LAND USE APPLICATION SUMMARY

Property Location: 2008 Bryant Avenue S
Project Name: 2008 Bryant Avenue Apartments
Prepared By: Mei-Ling Smith, City Planner, (612) 673-5342
Applicant: DDMZ Real Estate
Project Contact: Michael Stoddard, DJR Architecture
Request: To construct a new apartment building with 10 dwelling units.
Required Applications:

Site Plan Review	For a new apartment building with 10 dwelling units.
-------------------------	--

A4 4' TRASH CAN SCREEN - WOOD FENCE
1/4" = 1'-0"

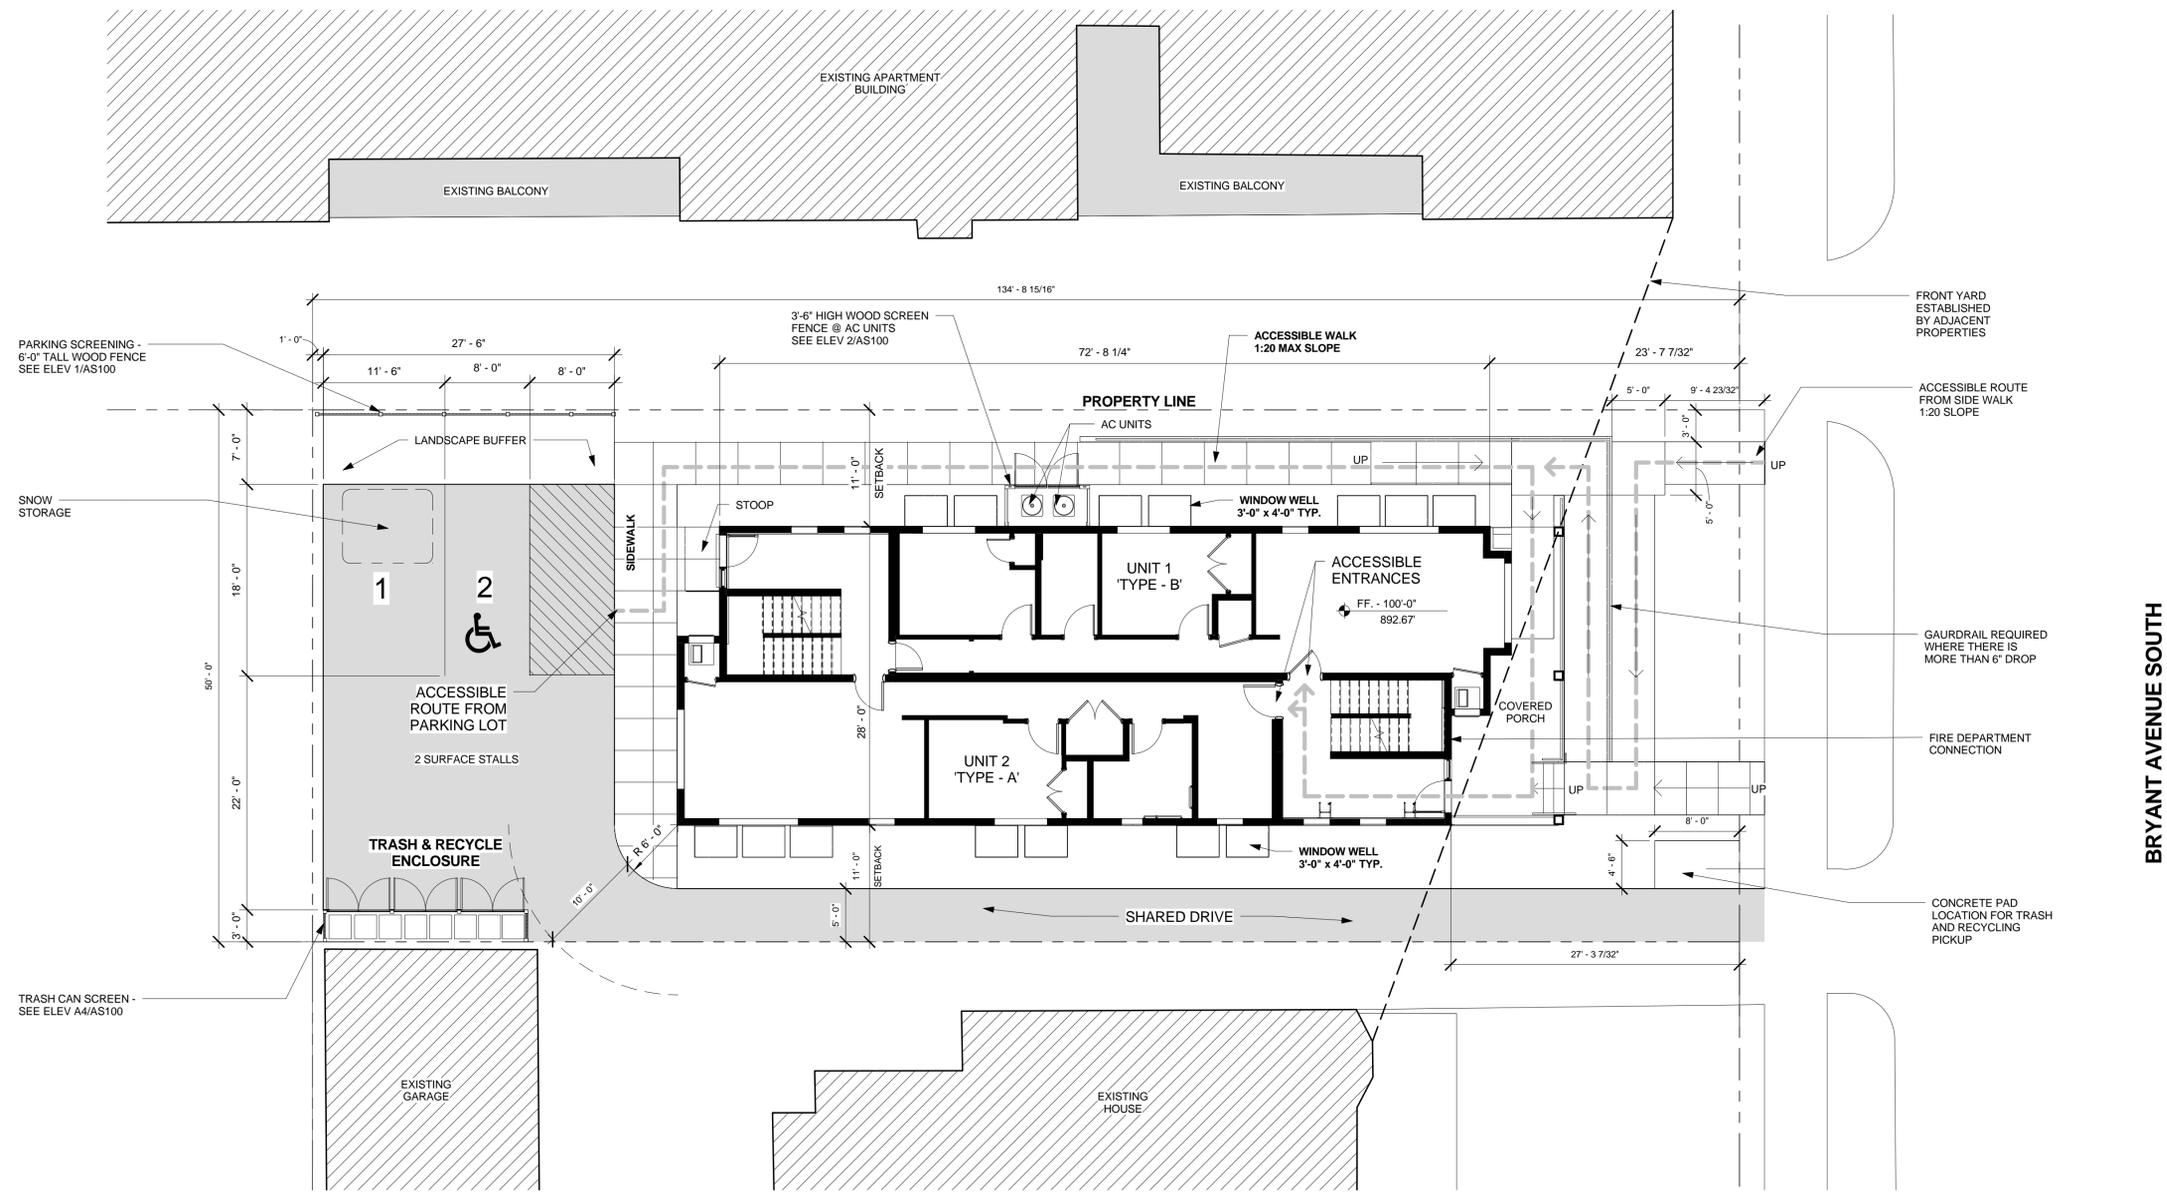
- The applicant is proposing a four-foot cedar fence to screen the trash and recycling containers in the southwest corner of the site. The site plan submitted by the applicant does not show the enclosure wrapping around the south side of the trash and recycling containers. In addition, the screen would not be at least two feet taller than the refuse and recycling bins. Staff recommends a condition of approval that requires the final site plan to be revised to demonstrate compliance with the screening requirements in section 535.80 of the zoning code.

7. The final plans shall be revised to demonstrate compliance with the refuse and recycling storage container screening requirements in section 535.80 of the zoning code.

LANDSCAPE PLAN

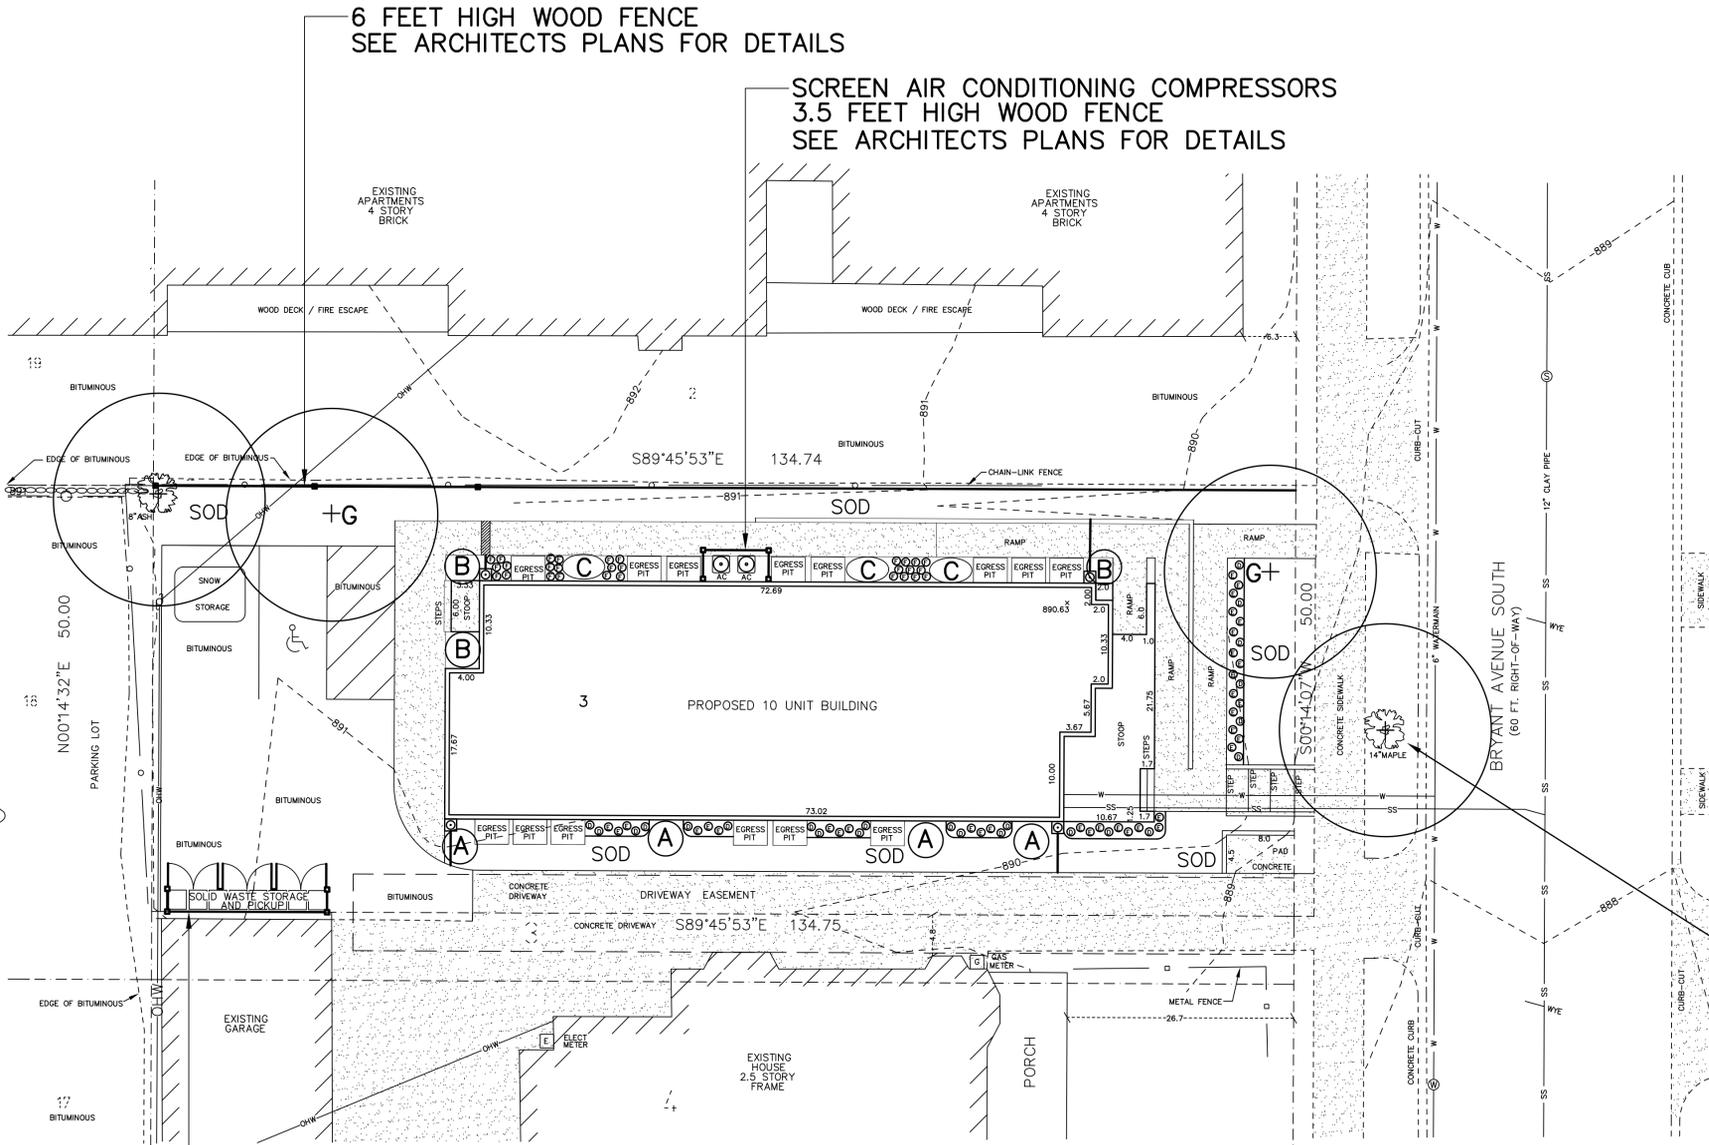
- The applicant is proposing at least one canopy tree per 500 square feet of the required landscaped area, including all required landscaped yards. The tree requirement for the site is two and the applicant is proposing a total of two canopy trees (Imperial Honeylocust). However, the submitted plan requires a total of two landscaped yards between the parking area and the north and south property lines, respectively. Each landscaped yard is required to be approximately 199 square feet in area. The landscaped yard is provided along the north property line but not along the south property line. Each landscaped yard is required to contain a minimum of one tree. This requirement is met within the north landscaped yard, but not the south, so the applicant is requesting alternative compliance for the minimum tree requirement along the south parking lot frontage.

- The applicant is proposing at least one shrub per 100 square feet of the required landscaped area, including all required landscaped yards. The shrub requirement for the site is 10 and the applicant is proposing 10 shrubs throughout the site. As described above, the required yards along the north and south parking lot frontages are required to also provide a total of one shrub per 100 square feet. Two shrubs are required in each parking lot frontage and no shrubs are proposed in either location. Alternative compliance is being requested.

- The parking area does not face the public street or sidewalk.
- The parking area abuts a residence district/residential use to the north and south. The applicant is proposing a seven-foot on-site landscaped yard of at least seven feet in width along the north

parking frontage, but is not proposing a landscaped yard along the south property line, where the trash and recycling enclosures would be located. This item requires alternative compliance.

- The applicant is proposing a six-foot cedar fence that is at least 95 percent opaque for the parking lot area facing the residential use to the north to meet the screening requirements in this location. However, the six-foot screen is not provided along the parking lot area facing the residential use to the south. The applicant is instead proposing a four-foot tall cedar trash enclosure for a portion of the parking lot frontage, and no screen where the driveway is located. Alternative compliance is requested.

5. The applicant shall provide no fewer than two shrubs in the required landscaped yard along the north parking lot frontage in order to comply with the minimum landscaping materials for required yards standards per section 530.160 of the zoning code.
